The Corporation of the Town of LaSalle

Date	July 17, 2017	Report No:	PW-22-17
Directed To:	Mayor and Members of Council	Attachments:	~ resident request ~ Canada Post/Town email chain ~ Figure 1
Department:	Public Works	Policy References:	
Prepared By:	Peter Marra, P.Eng. – Director of Public Works		
Subject:	Serenity Circle Community Mailbox

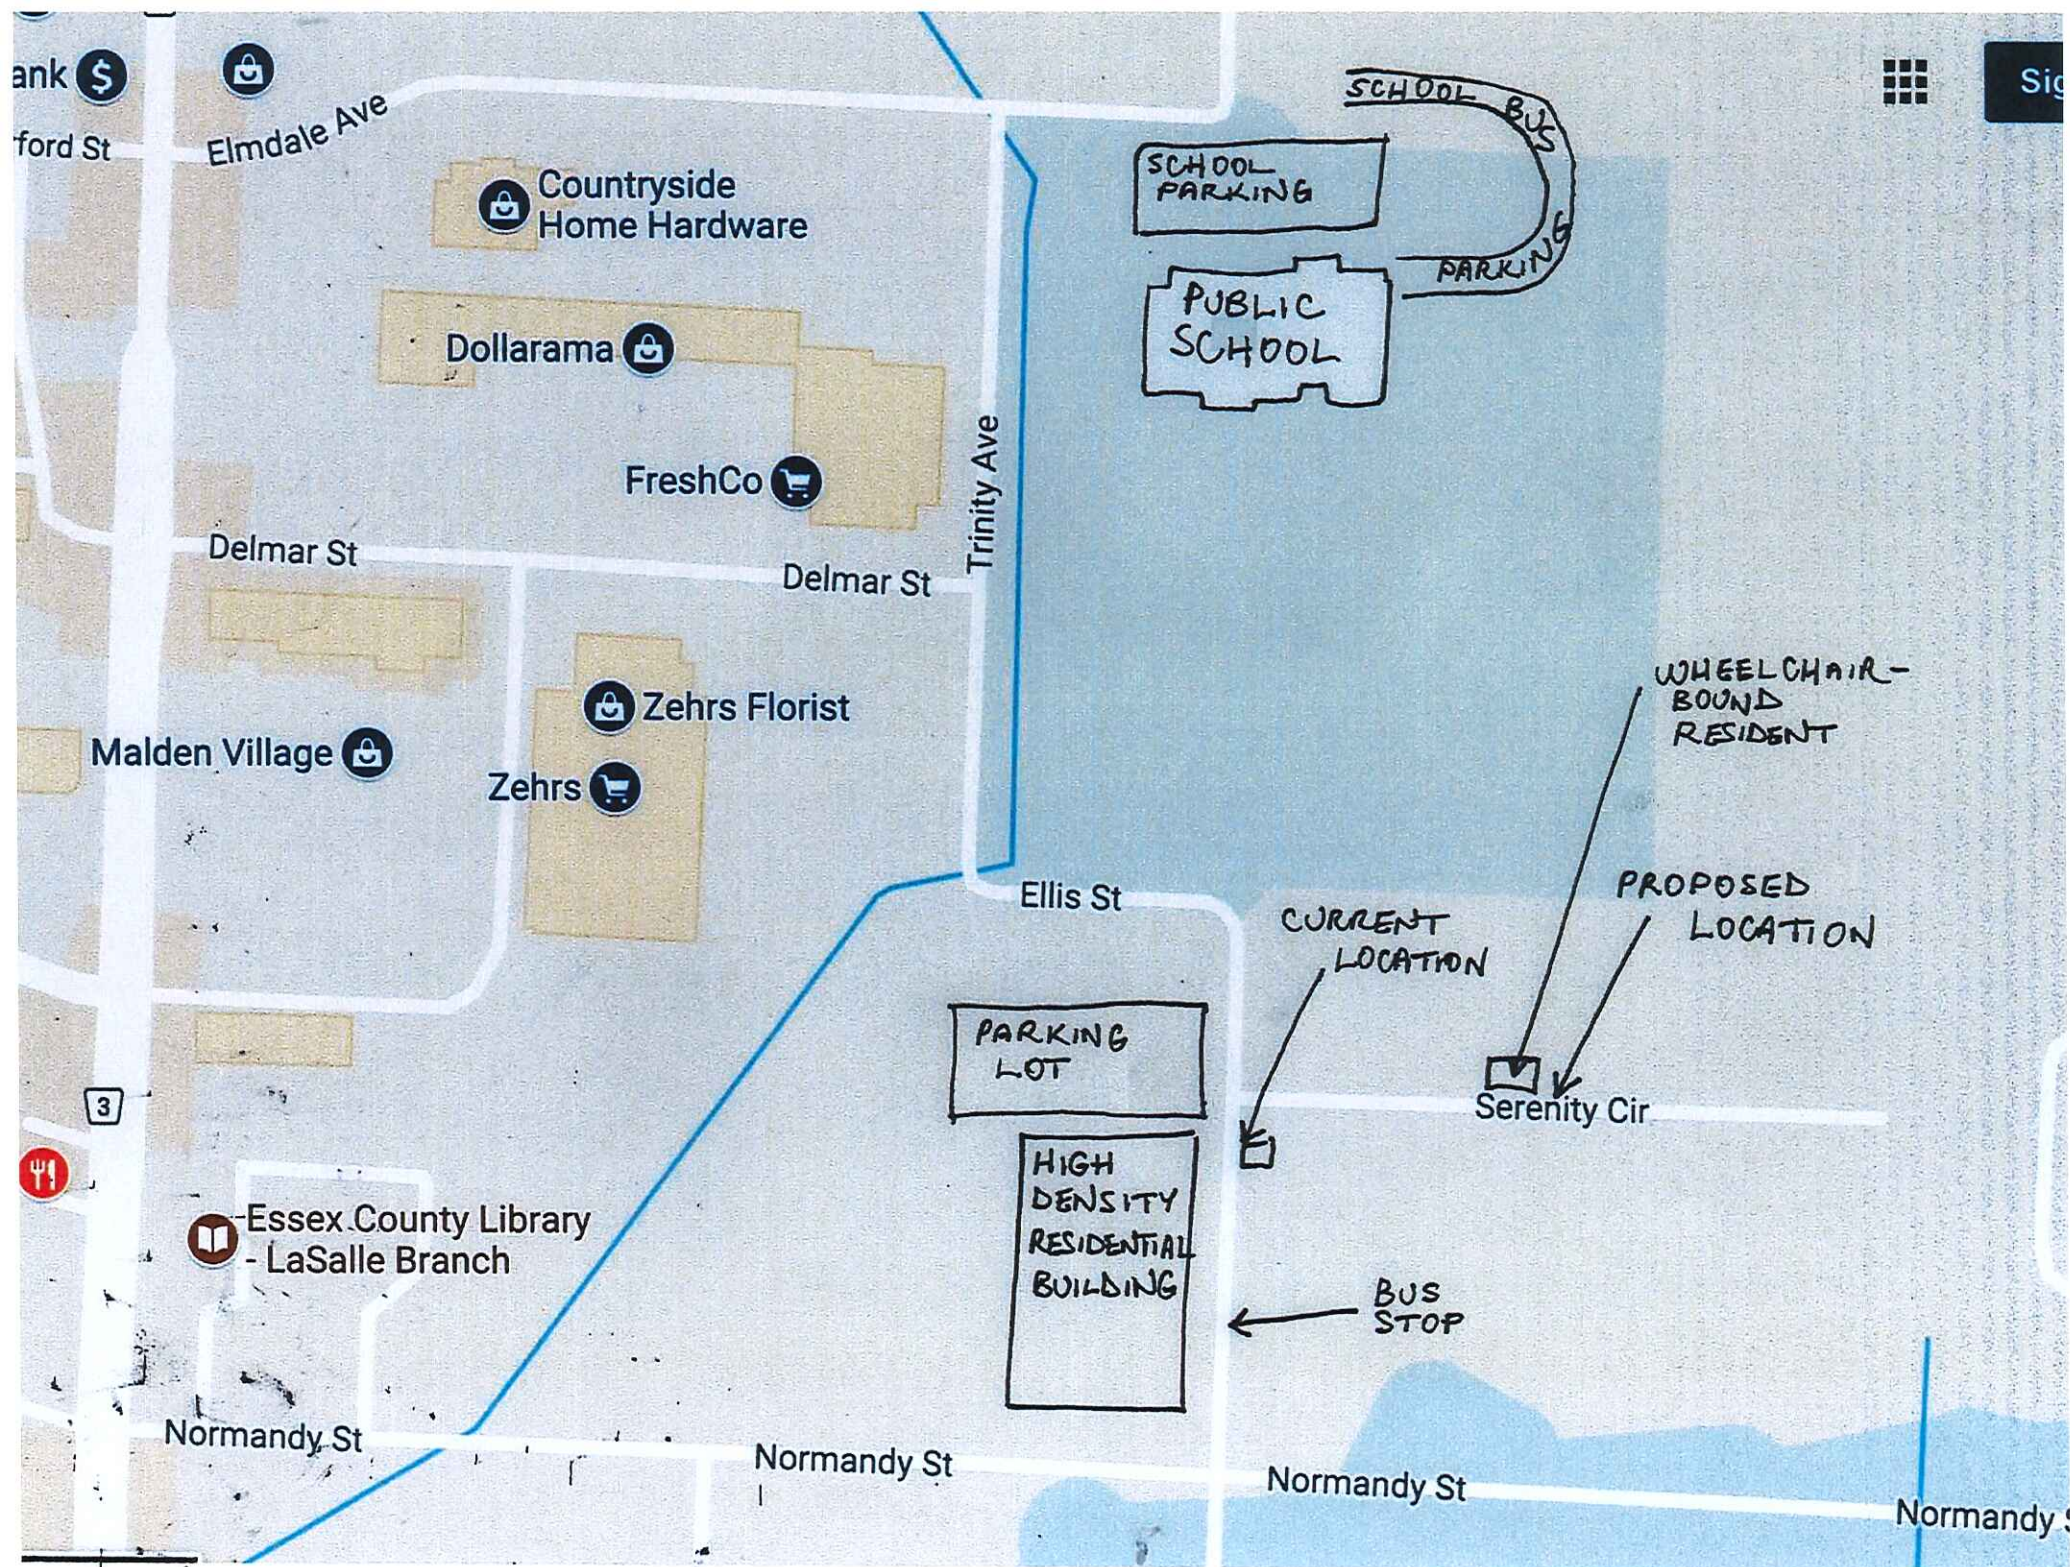
Please see attached slideshow. As can be seen on the map of the immediate area, Ellis Street is a feeder for a large school, a shopping area, and high density residential accommodation. The heavy traffic flow is confirmed by Town-legislated prohibition of parking/standing on Ellis. In addition, there is a prohibition of parking on Serenity in the immediate area of Ellis Street. In September of this year, bus service will come to LaSalle and a bus stop has been created on the East side of Ellis (same side as the community mail boxes on Ellis Street) between Serenity and Normandy Streets.

There is a wheelchair-bound resident on Serenity who is unable to retrieve his own mail. There are numerous elderly residents on Serenity who have serious difficulty accessing the mail boxes. Several residents have had close calls with injury, trying to access the boxes in traffic. There is nowhere to legally stop, either on Ellis or Serenity, to retrieve mail. Other neighbourhoods, many of which have nowhere near the traffic that Ellis experiences, have inlets to pull a vehicle off the road to stop to retrieve mail. No such opportunity exists in this area.

Serenity Circle is a one-block cut-de-sac which has no through traffic. The proposed location of the boxes is approximately half-way down Serenity.

In addition to the safety of the residents, the Canada Post delivery van driver is exposed to injury every day when stopping (illegally) to stuff the boxes. The delivery van impedes traffic in the process. There is an area immediately in front of the proposed location on Serenity where the driver can stop in safety without impeding traffic.
